LR-N05-0213
LCR H04-01

**RESPONSE TO REQUEST FOR ADDITIONAL INFORMATION
REQUEST FOR CHANGE TO TECHNICAL SPECIFICATIONS
ARTS/MELLLA IMPLEMENTATION
HOPE CREEK GENERATING STATION
FACILITY OPERATING LICENSE NPF-57
DOCKET NO. 50-354**

**HOPE CREEK GENERATING STATION
FACILITY OPERATING LICENSE NPF-57
DOCKET NO. 50-354
RESPONSE TO REQUEST FOR ADDITIONAL INFORMATION
ARTS/MELLLA IMPLEMENTATION**

Figure 1c-1

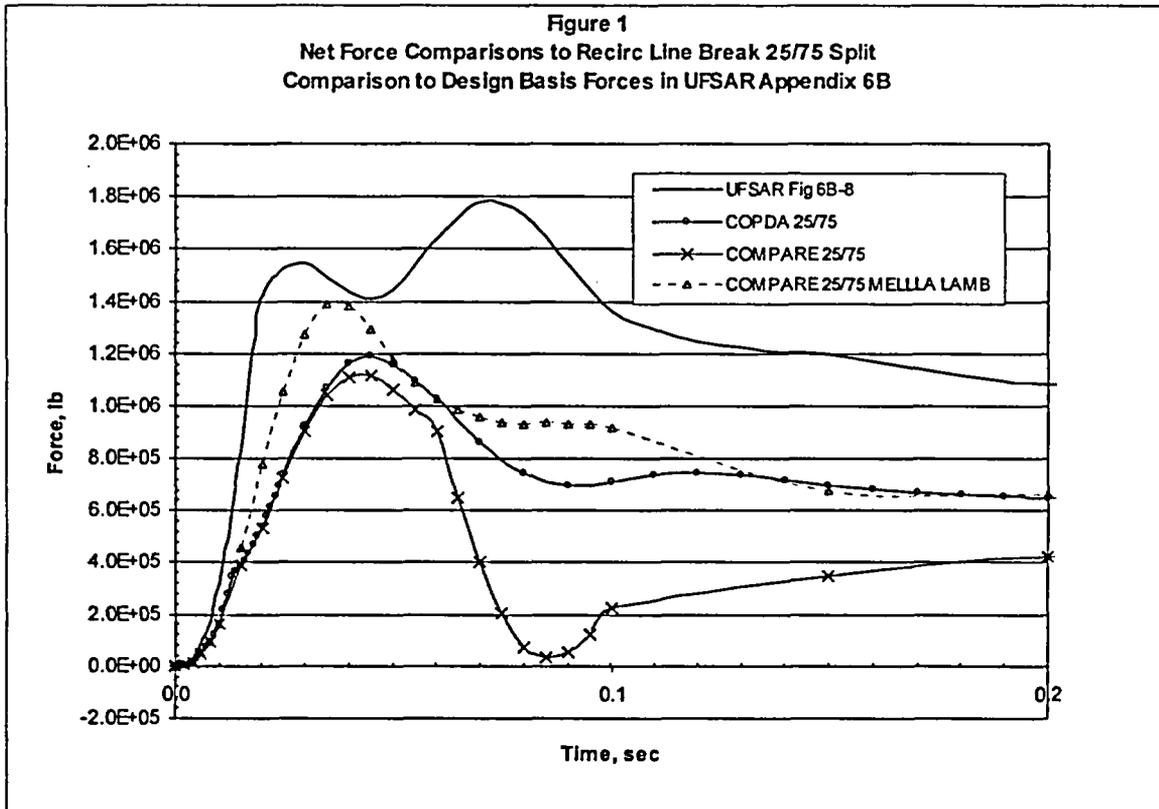
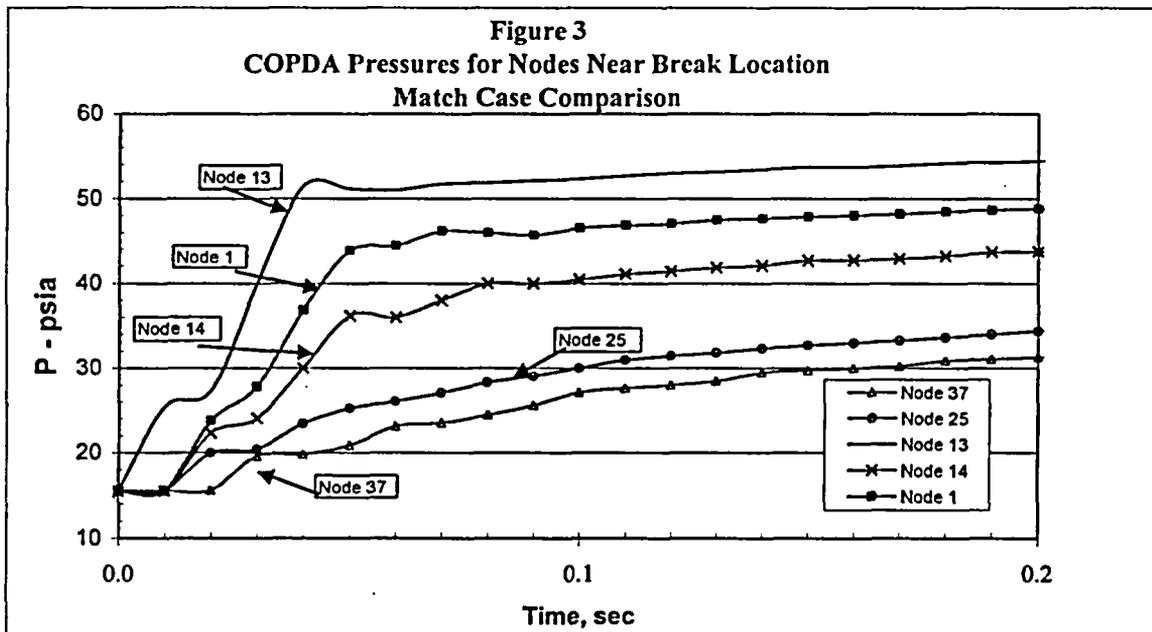
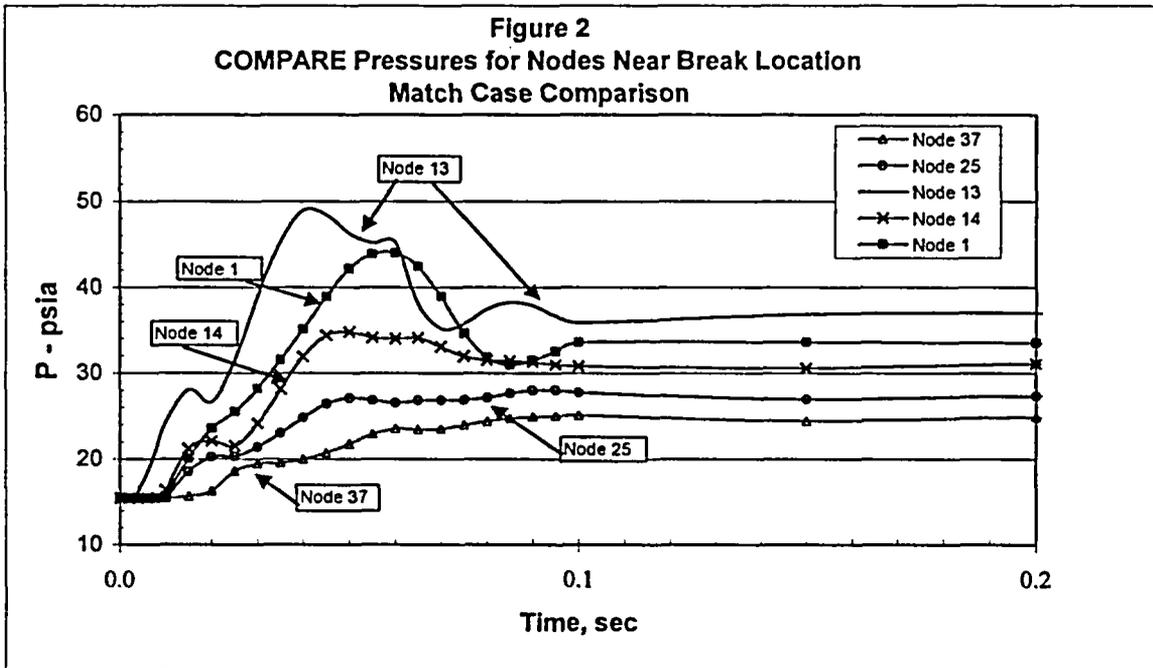
Figure 1c-1 shows resultant force time histories similar to UFSAR Figure 6B-8. These comparisons show the HCGS design basis (50% - 50% flow split) and the COPDA and COMPARE match cases with 25% - 75% flow splits. Also, shown for comparison is the reactor vessel resultant force for MELLLA LAMB M/E with a 25%-75% split.

COMPARE and COPDA pressure and net force comparisons were made for the 25% - 75% flow split case. COMPARE calculated pressure time histories that resulted in a total vessel force within approximately 7 percent of the maximum force predicted using COPDA's pressure time histories. In general, the COPDA analysis typically resulted in higher nodal pressures and differential pressures in the vicinity of the blowdown nodes. In the COMPARE analyses, the break mass and energy was more rapidly distributed resulting in higher nodal pressures away from the blowdown site for the time period from the break opening through the time of maximum resultant force. However, the resultant forces using the pressure results predicted by the COPDA and COMPARE codes were similar through the time of maximum resultant force. These forces were calculated in the same manner as described in Appendix 6B of the UFSAR.

Figures 1c-2 and 1c-3

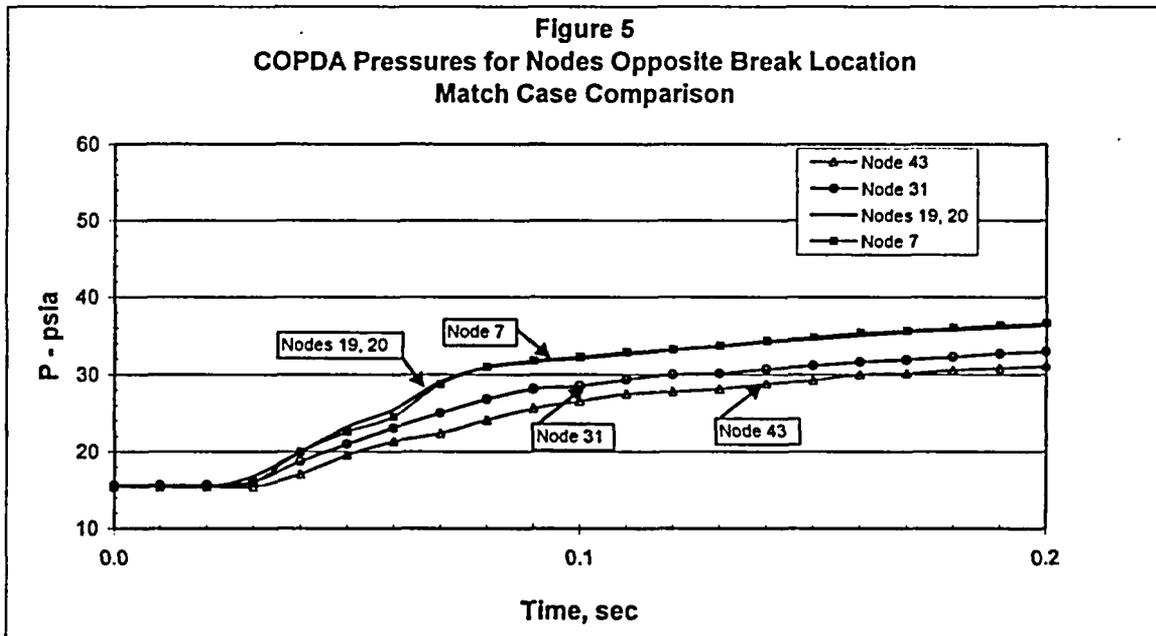
Figures 1c-2 through 1c-7 show comparisons of significant pressure nodes and differential pressures predicted by COMPARE and COPDA through the time of maximum resultant force for the 25%-75% match case. Pressures for nodes 24 and 18 are similar to nodes 13 and 19, etc. due to symmetry (see UFSAR Figure 6B-3a), and are not shown in the plots.

Figure 1c-8

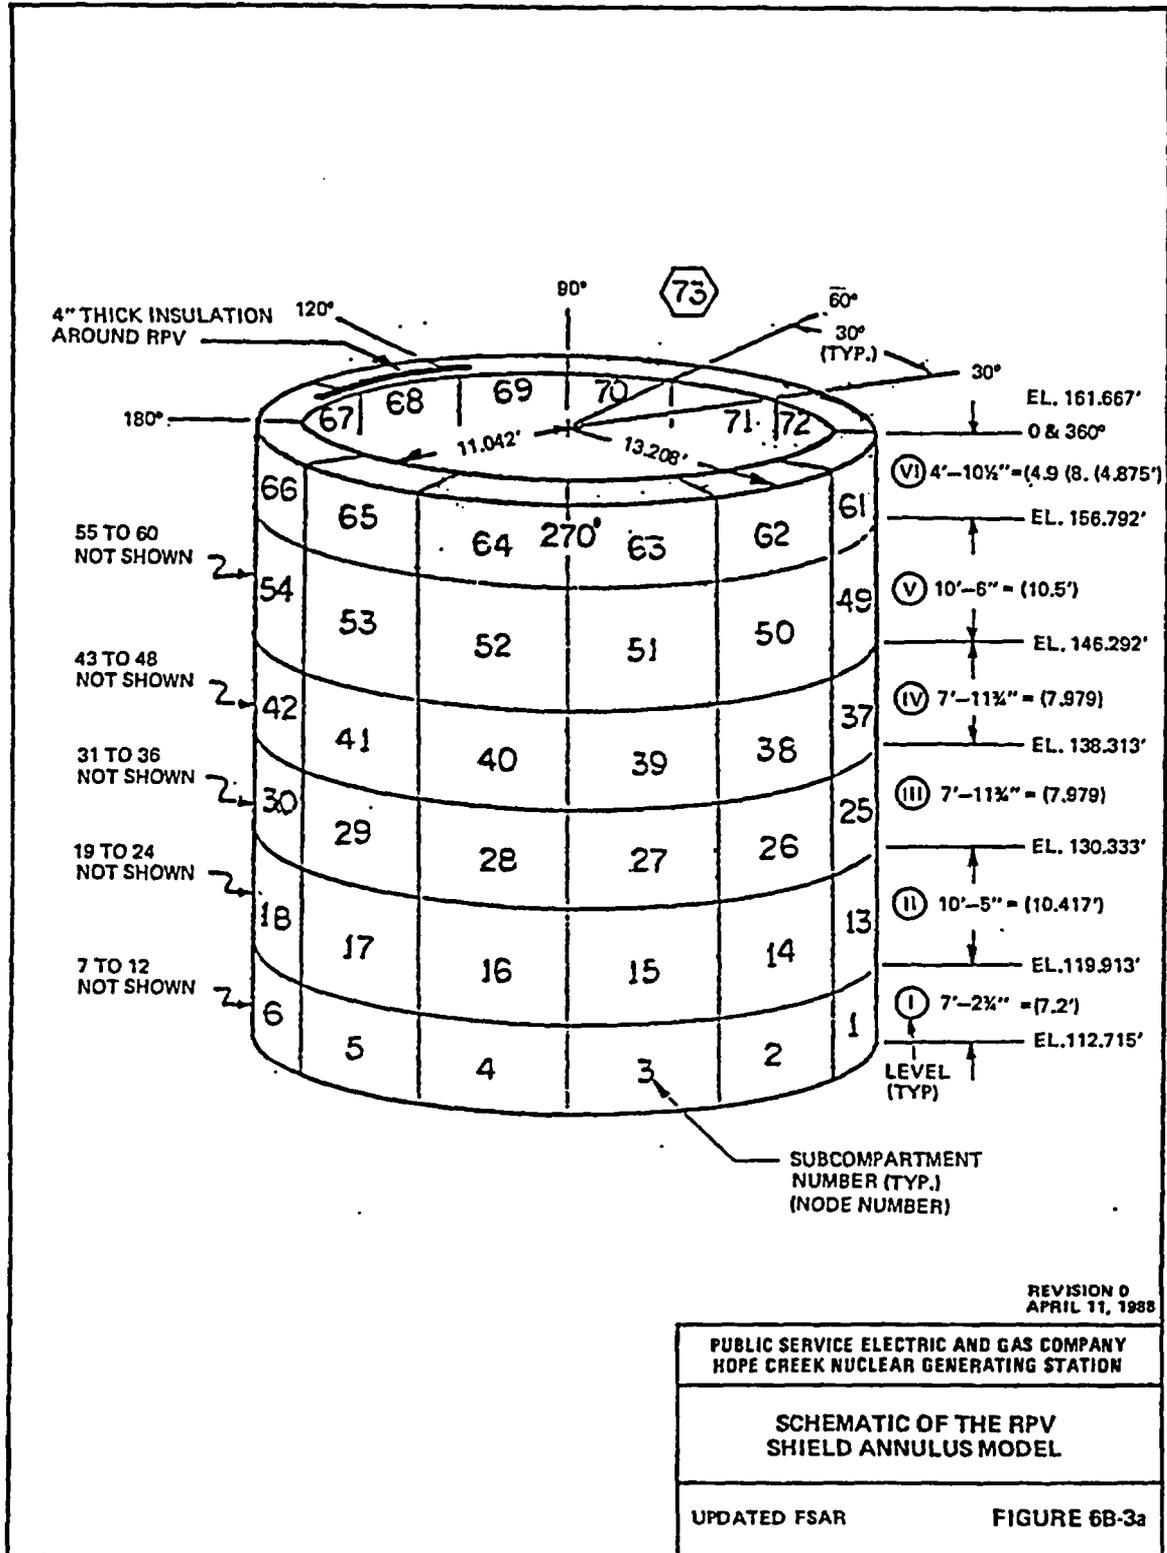
Comparisons of significant (in terms of resultant force contribution) control volume and differential pressures were made for COMPARE and COPDA. UFSAR Figure 6B-3a shows the nodal layout and is provided in this attachment as Figure 1c-8. The recirculation outlet is located at the boundary between nodes 13 and 24. One half of the recirculation line break annulus blowdown goes into nodes 13 and 24, respectively. Node 14 is on the same elevation

adjacent to node 13 going away from the blowdown region. Node 1 is immediately below node 13 extending to the vessel skirt; nodes 25 and 37 are immediately above (in elevation) node 13. Nodes 19, 20, 7, 31 and 43 are diametrically on the opposite side of the vessel from these nodes and result in larger differential pressures relative to the break location and elevation.

Figure 1d-1

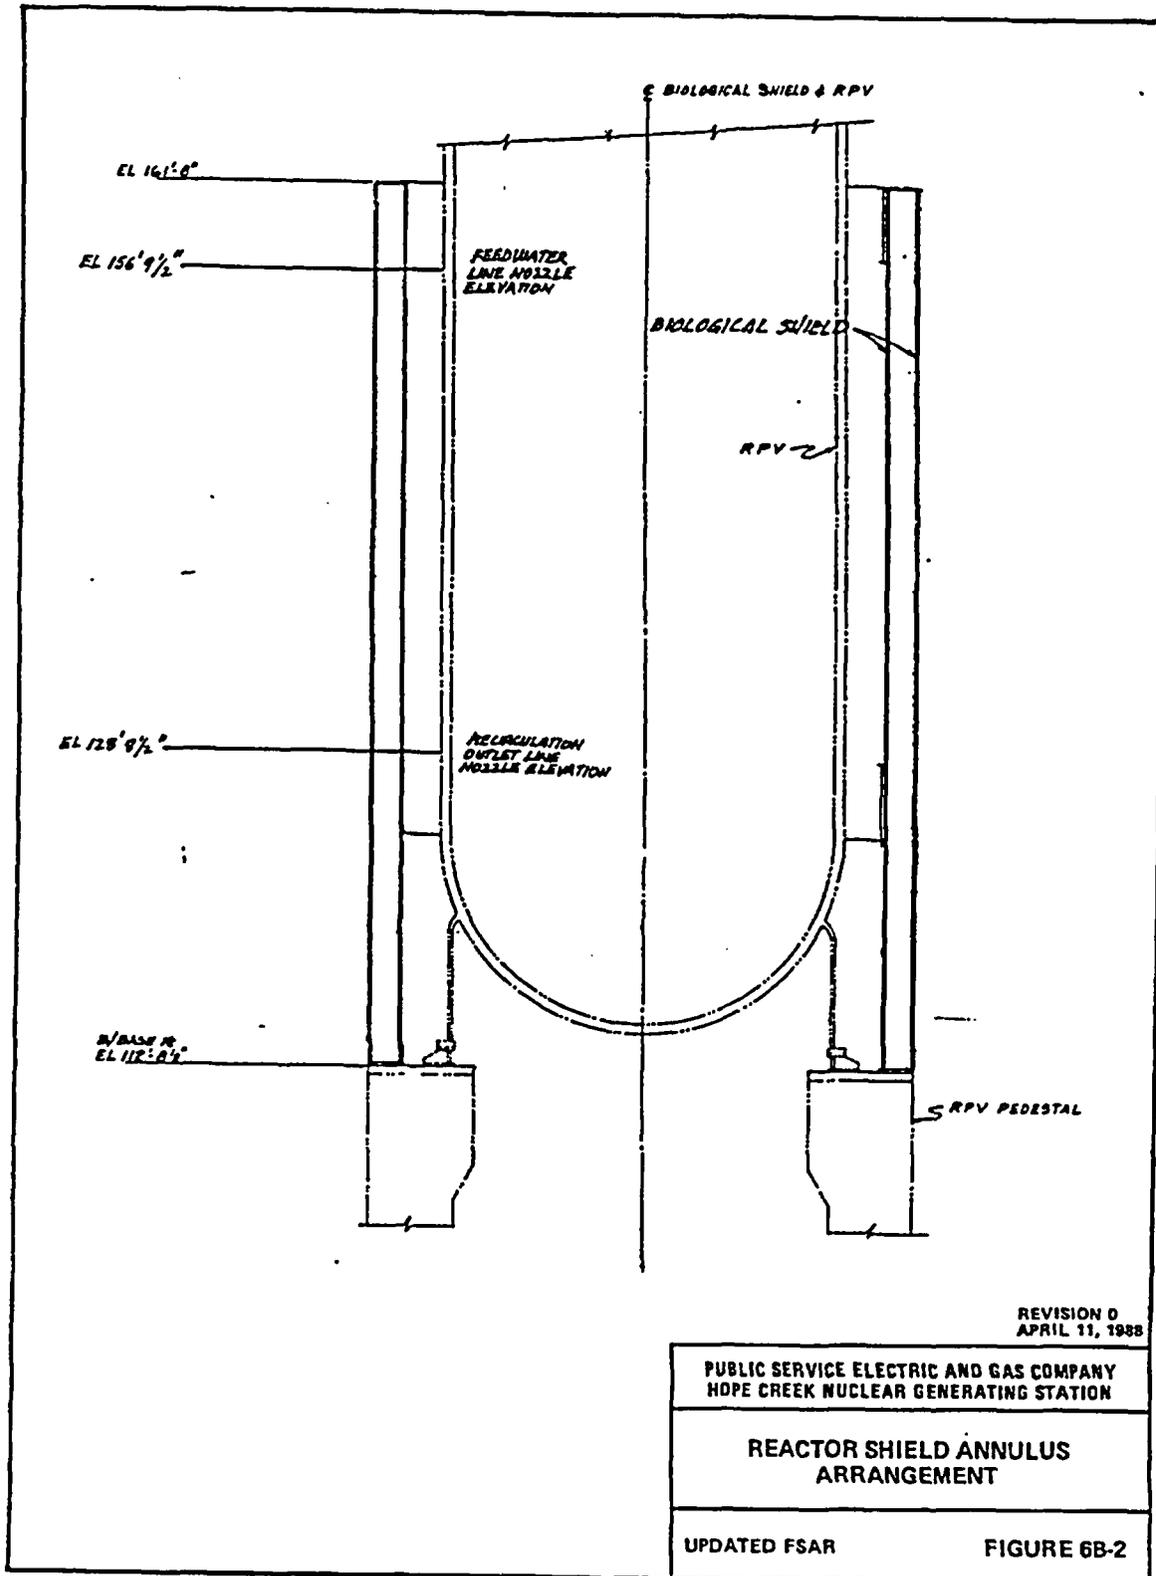
- d) Provide a design description of annulus region and the existing 25/75 flow diverter which limits the break flow into the annulus to 25% of the nominal value. Where is the postulated break located (i.e., on the recirculation or the feedwater line) and where does the remaining flow go? Is this flow reduction the major contributor to meeting the design requirements? Was the diverter considered in the original code calculations? If not, was a COPDA calculation [done] with the diverter, and what were the results?

The general layout of the annulus region between the reactor pressure vessel and the biological shield wall is shown on Updated Final Safety Analysis (UFSAR) Figure 6B-2, provided here as Figure 1d-1. The flow diverters installed in the shield wall penetrations for the recirculation outlet lines are shown in UFSAR Figure 6B-1, provided here as Figure 1d-2.
